CHANGE ORDER

Project Name: **Haverhill Consentino Middle School** CO No. **10**

Architect's Project No. **21-0818**

CCD / PR / PCO #	Description	Amount
PCO 064	Controls Mounting Height	\$ 6,715.17
PCO 066	PR-12R1 RFI 57 Duct Chase	\$15,993.95
PCO 073	Music Storage Cabinet Doors	\$13,225.78
PCO 076	PR-47 RFI 183 Rated Horizontal Assembly	\$7,958.60
PCO 078	Modified Window Trim	\$25,390.41
PCO 081	Multivista Construction	\$29,077.65
PCO 083	Set Second Utility Pole	\$4,950.16
Total		\$103,311.72

A4 ROOM CONTROL LAYOUT - TYPE RC-A AND RC-AX

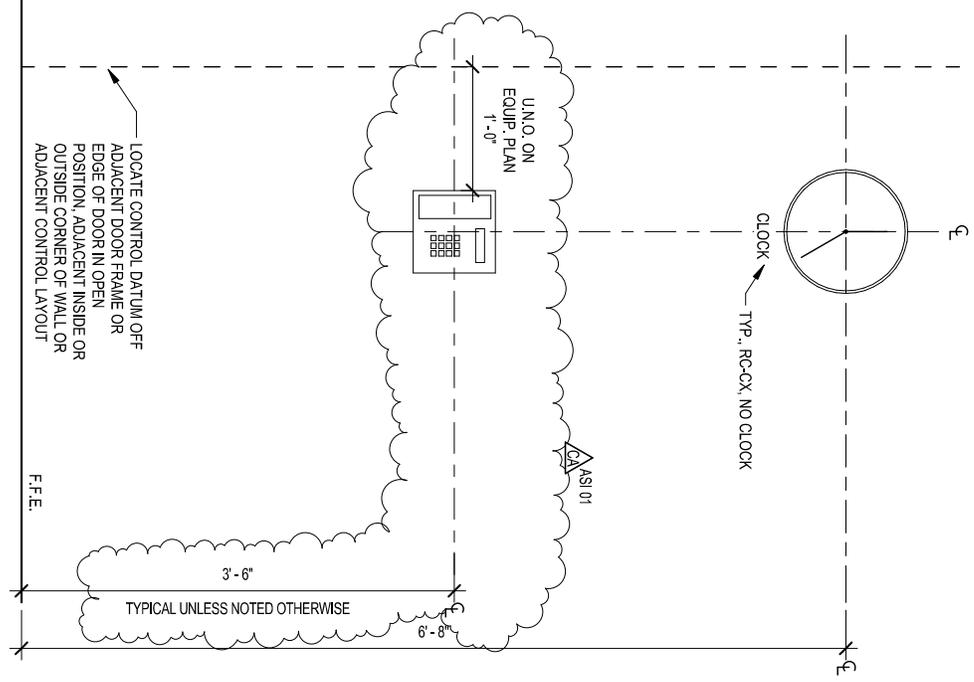
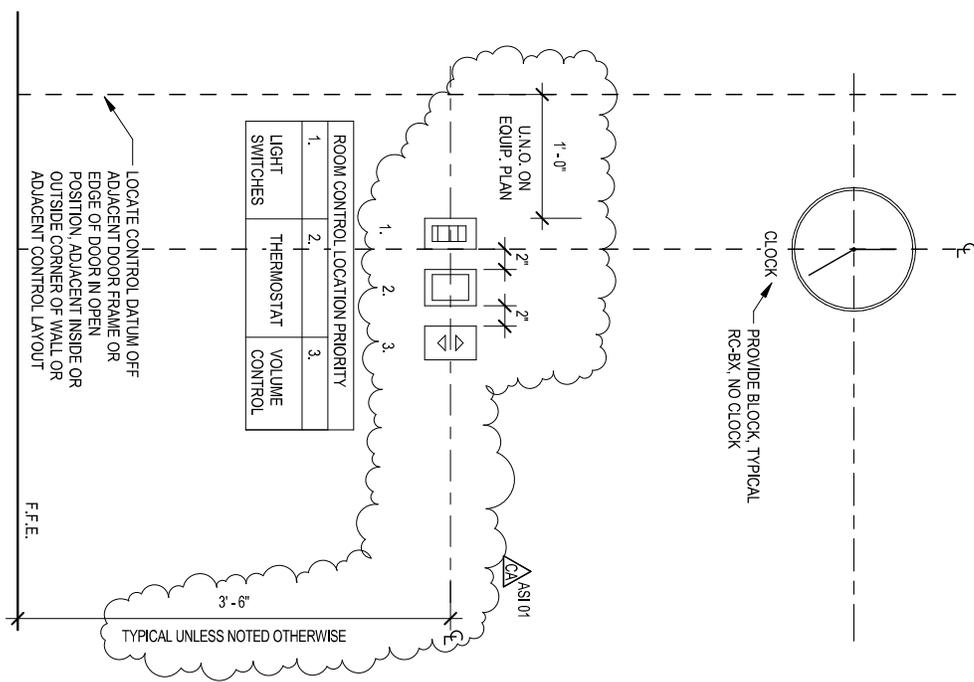
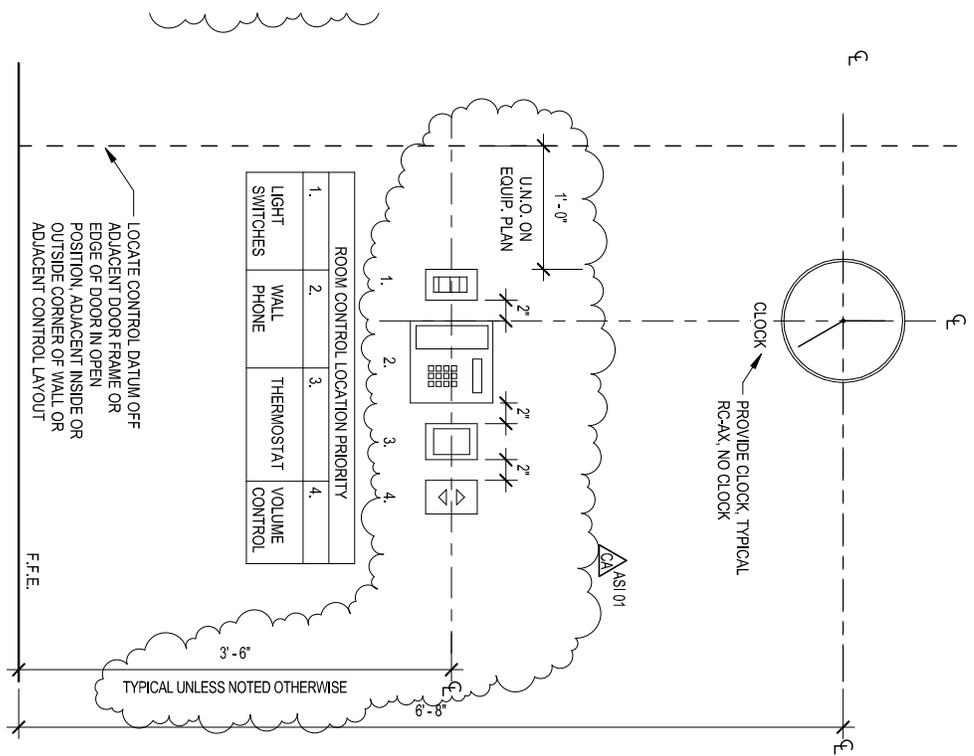
At Sheet A9.51, Interior Details, revise the height of the controls at A12, A8 and A4 as shown on attached sketch **JD-01** and **JD-02**.

Make corresponding changes to interior elevations in the contract drawing set including the following: AQ1.50, AQ1.51, AQ1.52, AQ1.53, AQ1.54, AQ1.55, AQ1.60, AQ1.61, AQ1.62, AQ1.63, AQ1.64, AQ1.65, AQ1.66, AQ1.67.

JD-03

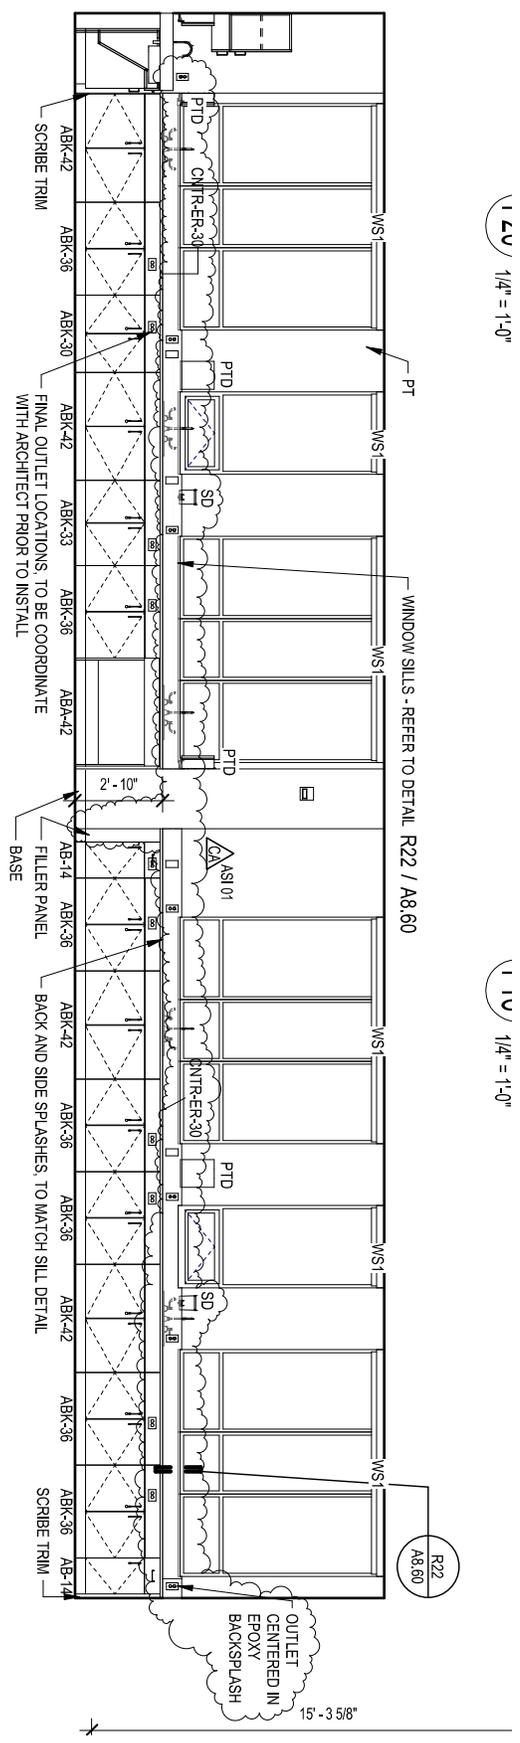
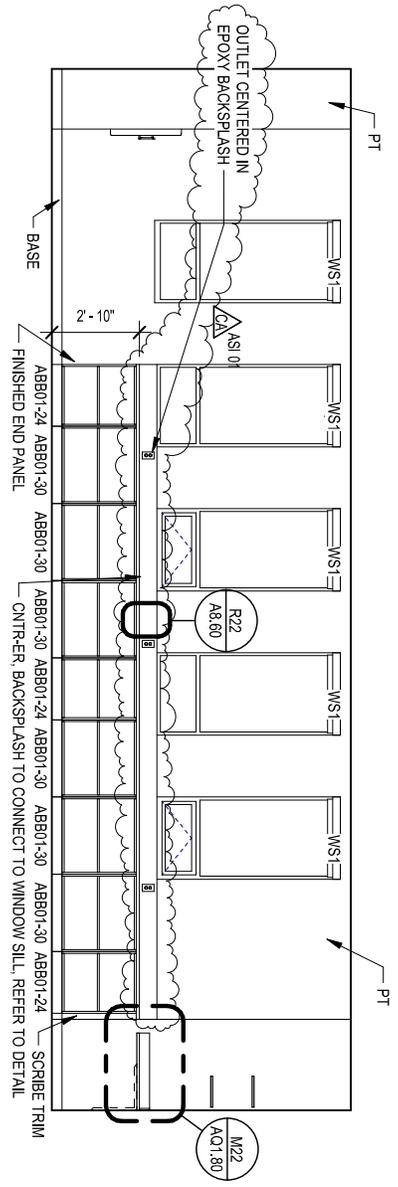
At Sheet AQ1.51, Casework Plans and Elevations, at D21 Interior Elevation – Science Classroom Exterior, adjust outlet locations at epoxy counters as shown on attached sketch **JD-03**. Make similar revision to D22/AQ1.52 and N18/AQ1.53.

JD-15

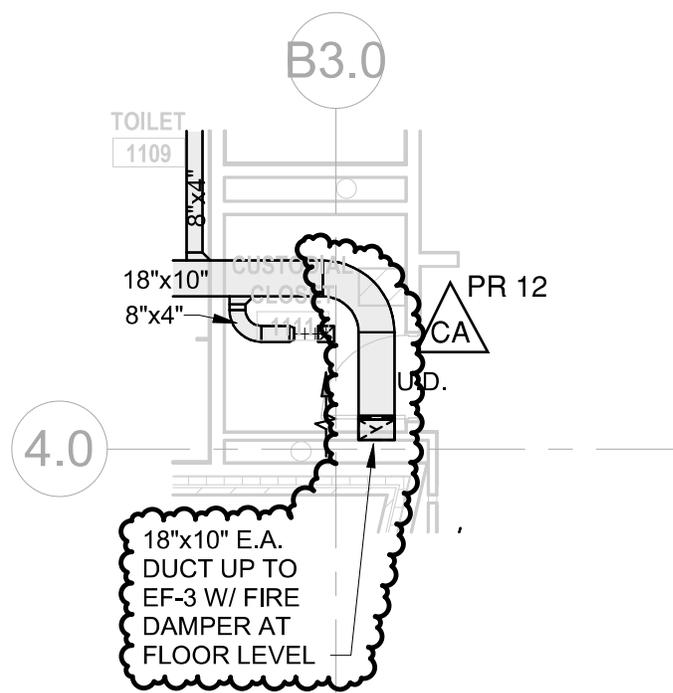
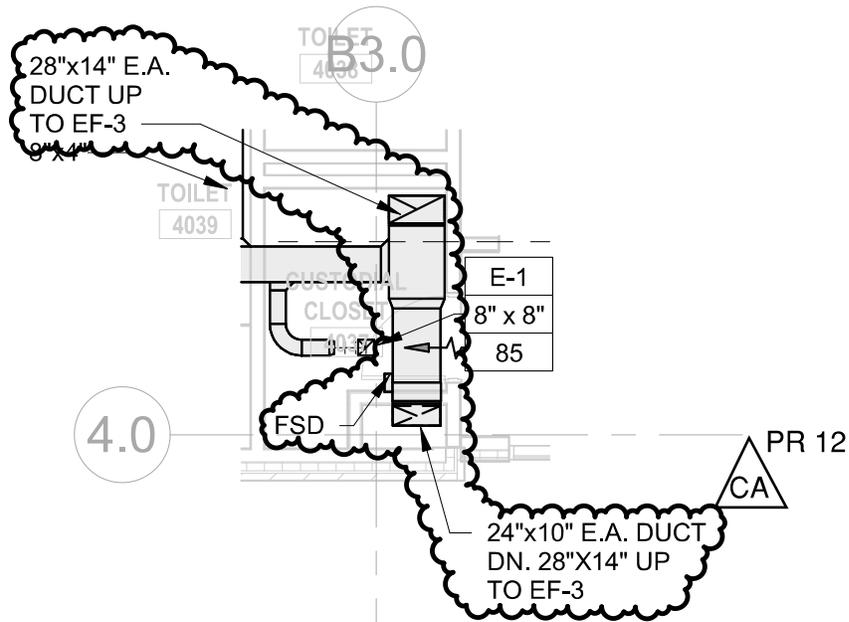
Sketches "JD-15" and "JD-16" attached to PR-012 indicate two different kinds of a life-safety dampers. Tag provided on ductwork indicate "FSD" which would be Fire Smoke Damper
 Call-out notes provided on sketches indicate "Fire Damper"
 Please clarify which type of life-safety dampers are required.

At Sheet M1.11, HVAC – Fire Floor Plan – Area A / B Ductwork and Sheet M1.21, HVAC – Second Floor Plan – Area A / B Ductwork, revise layouts as shown on attached sketch **JD-15**.

JD-16

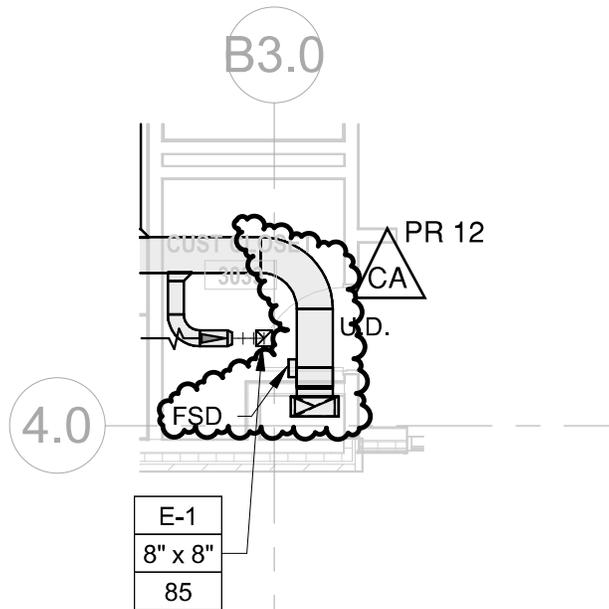
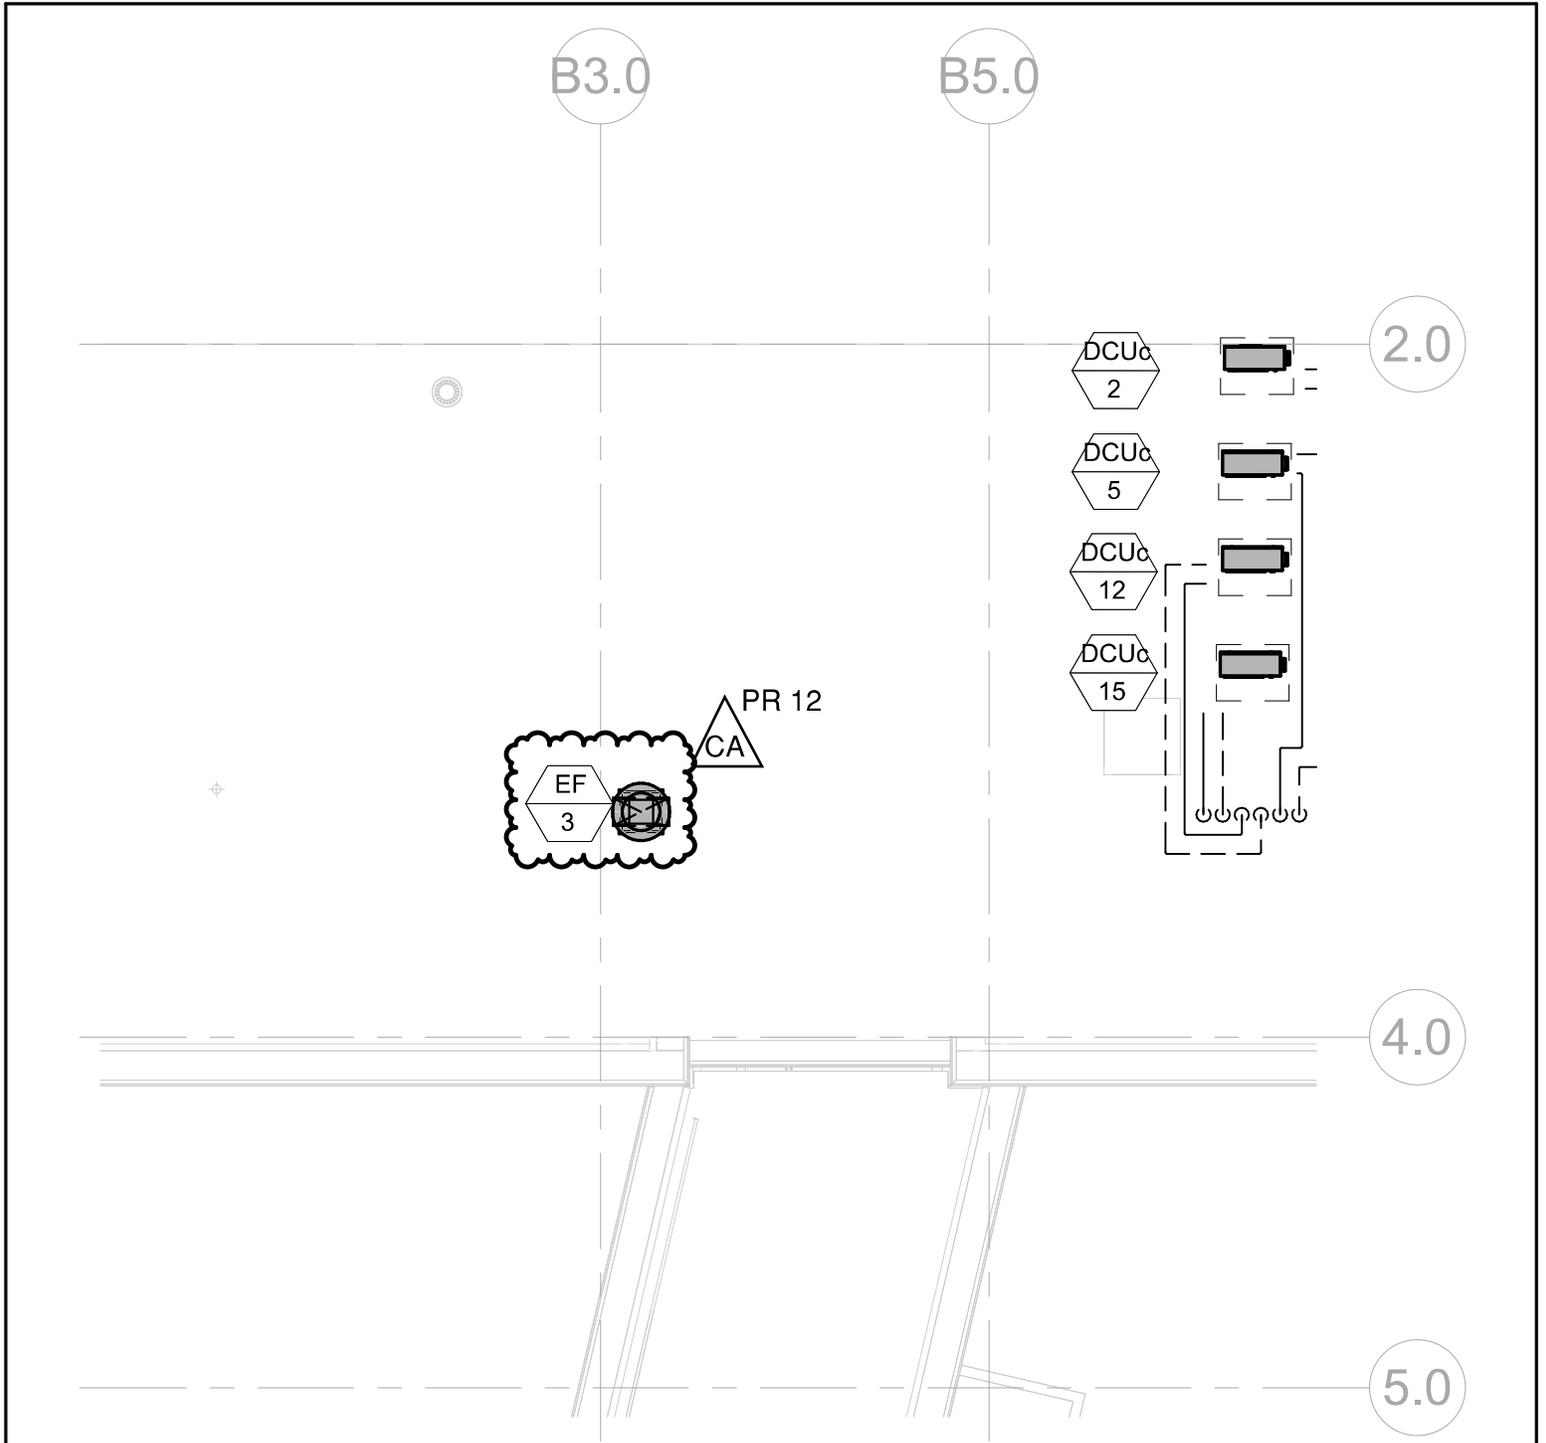
At Sheet M1.31, HVAC – Third Floor Plan – Area A / B Ductwork and Sheet M1.41, HVAC – Fourth Floor Plan – Area A / B Ductwork, revise layouts as shown on attached sketch **JD-16**.

10
JD15
M10

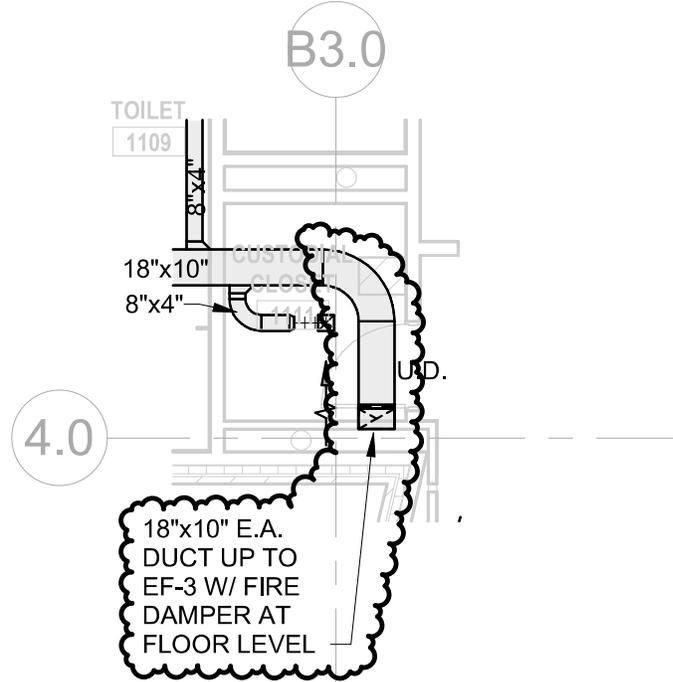
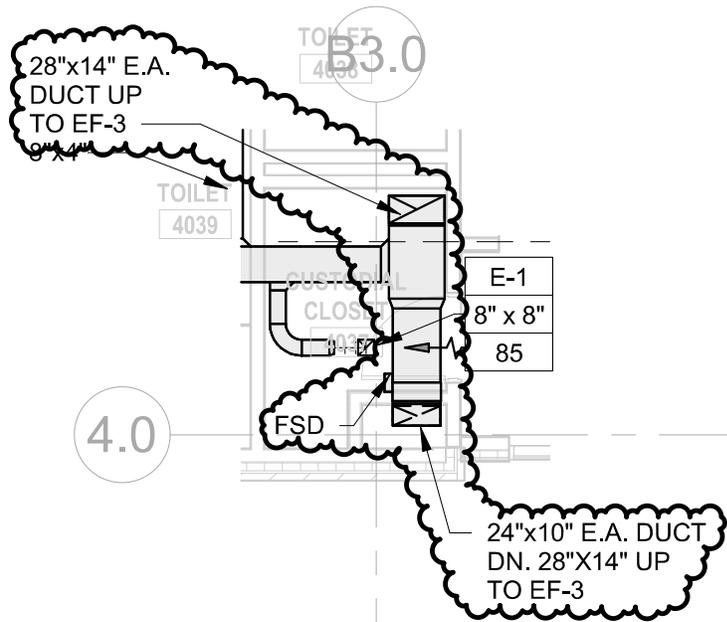
At Sheet M1.11, HVAC – Fire Floor Plan – Area A / B Ductwork and Sheet M1.21, HVAC – Second Floor Plan – Area A / B Ductwork, revise layouts as shown on attached sketch **JD-15**.

JD16
M11

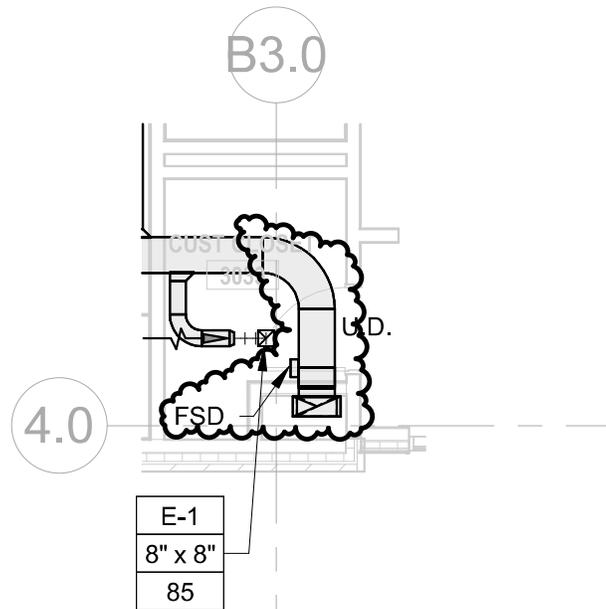
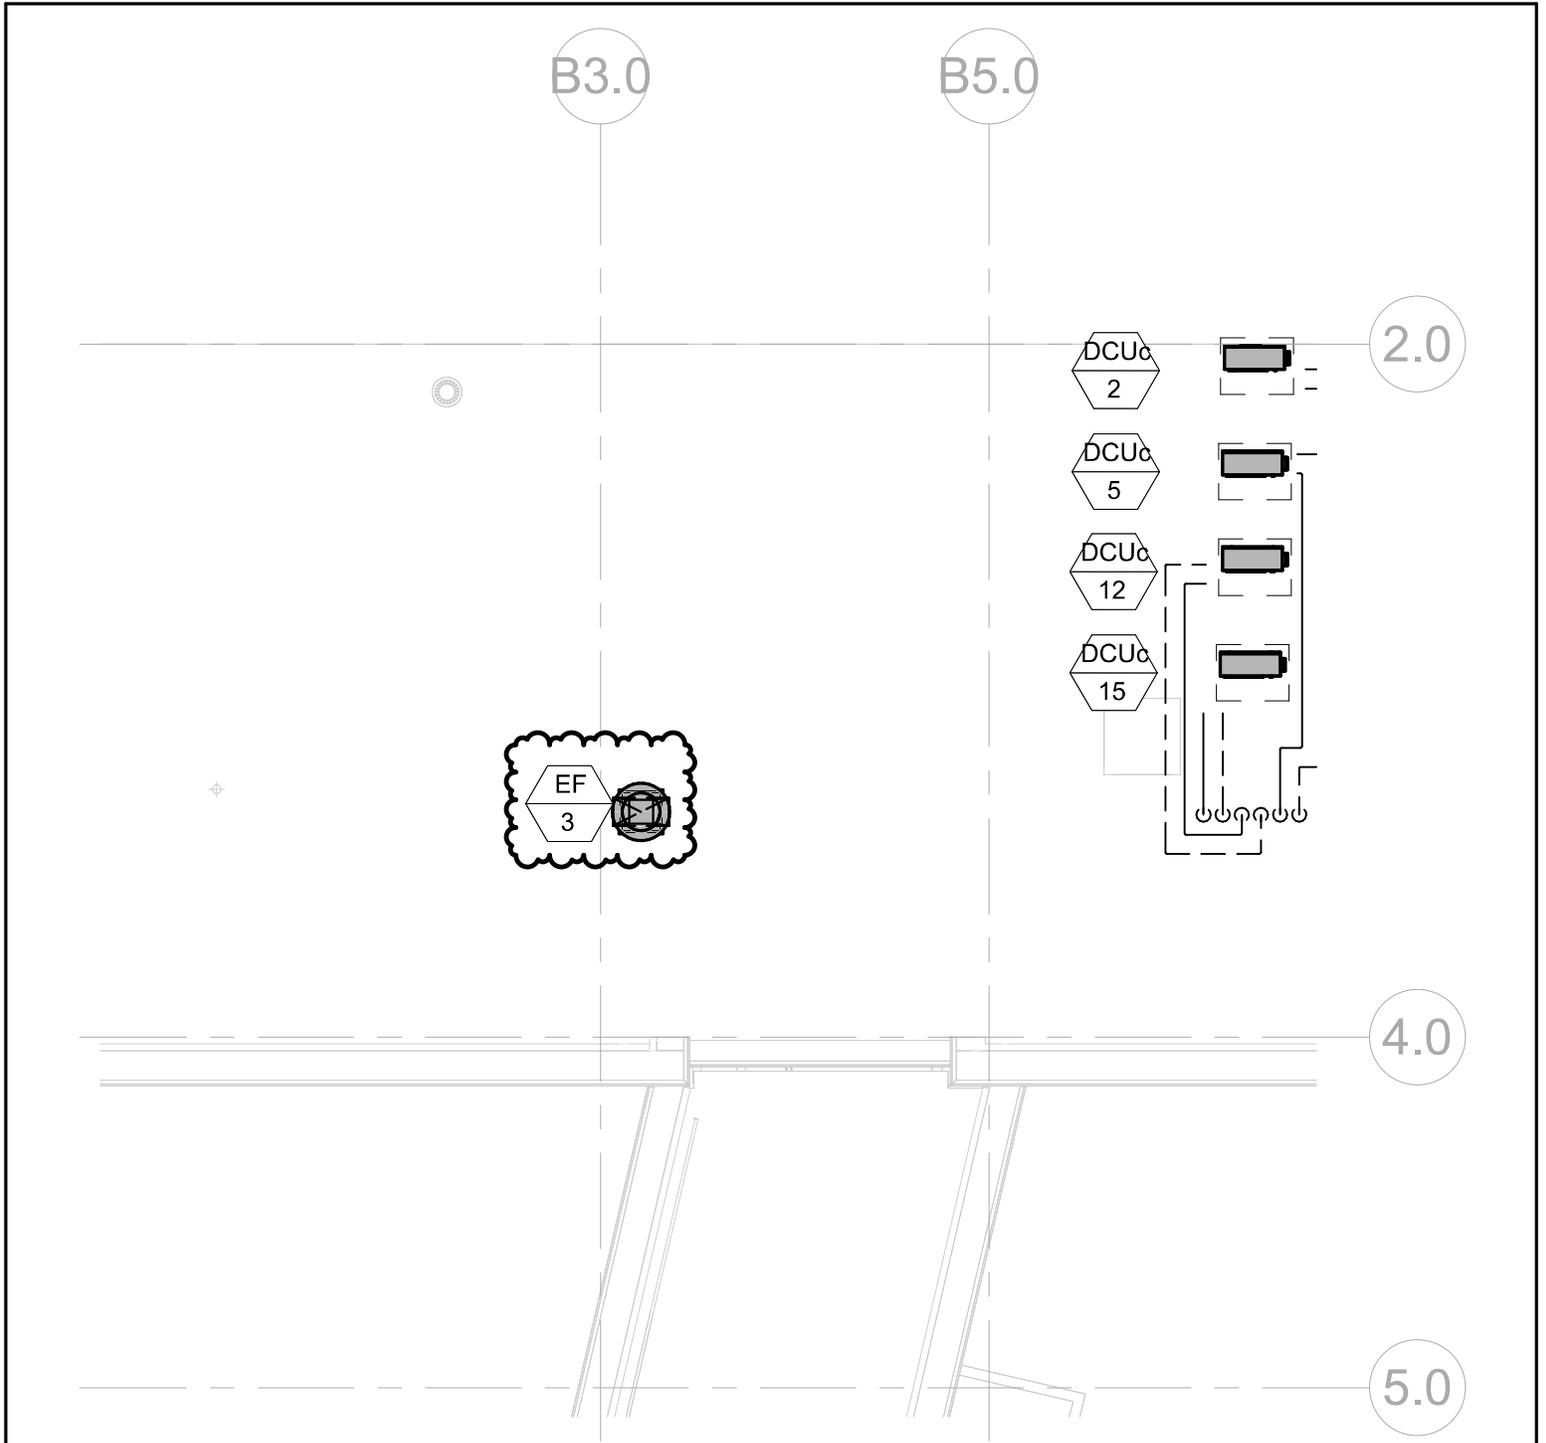
At Sheet M1.31, HVAC – Third Floor Plan – Area A / B Ductwork and Sheet M1.41, HVAC – Fourth Floor Plan – Area A / B Ductwork, revise layouts as shown on attached sketch **JD-16**.
